## 15.7 Radioactive Release from Subsystems and Components

The information in this section of the reference ABWR DCD, including all subsections, figures and tables, is incorporated by reference with the following departure and supplements.

STD DEP 11.3-1 (Figure 15.7-2)

Figure 15.7-2 Offgas System (See Subsection 11.3)

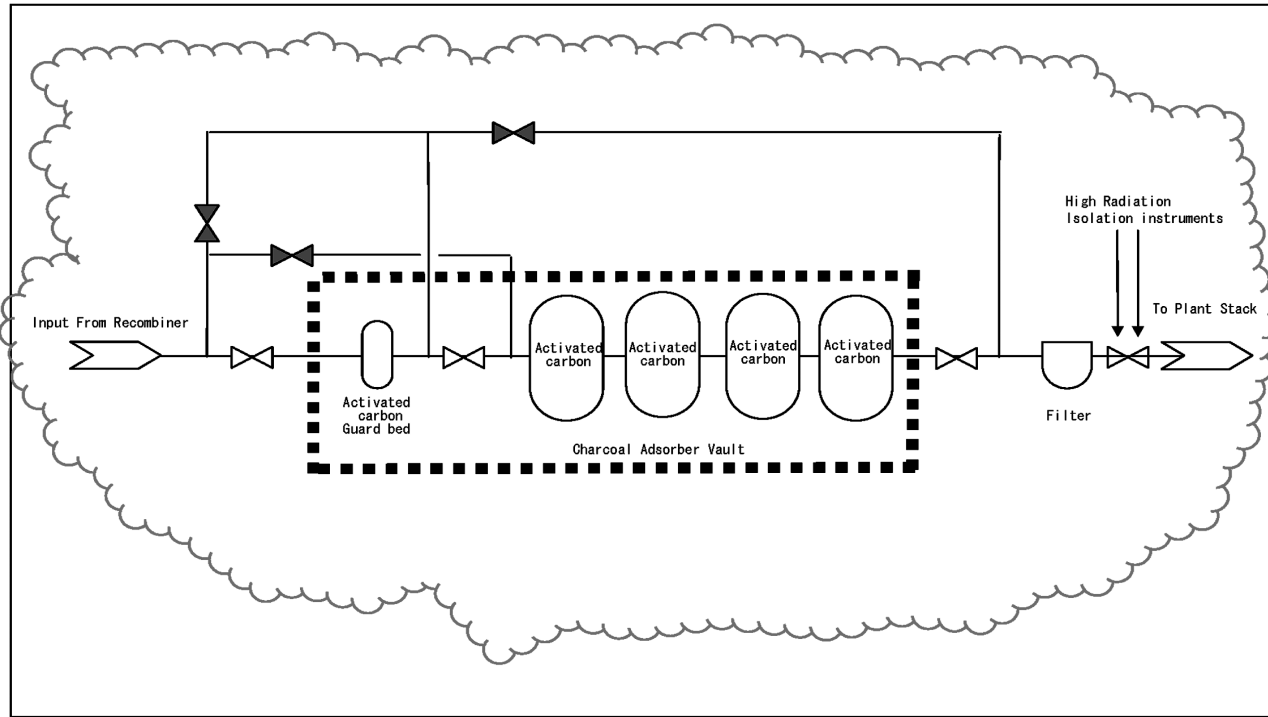
*To evaluate the potential radiological consequences of an inadvertent bypass of the charcoal beds, it was assumed that operator error or computer error has led to the bypass of the ~~eight~~four follow-on beds in addition to the failure of the automated air operated downstream isolation valve. It is also assumed that during this period, the plant is running at and continues to run at the maximum permissible offgas rate of 14.8 GBq/s (based upon the assumption of 0.0037 GBq/s/MWt as stipulated in Standard Review Plan 11.3) evaluated to a decay time of 30 minutes from the vessel exit nozzle. Even with the failure of the downstream isolation valve, it is not anticipated or assumed that the isolation instrumentation would fail but would instead*

- (1) Flow is through a single 4,721 kg charcoal tank with an evaluated hold up time given by NUREG-0016, equation 1.5.1.6 using  $K_d$ 's for Kr and Xe from NUREG-0016.
- (2) ~~An isolation valve prevents flow through the~~ ~~There is no motive force to~~ ~~remove any significant inventory from the eight~~ follow-on charcoal tanks while in bypass and therefore no activity from these tanks is included in the final release calculations.
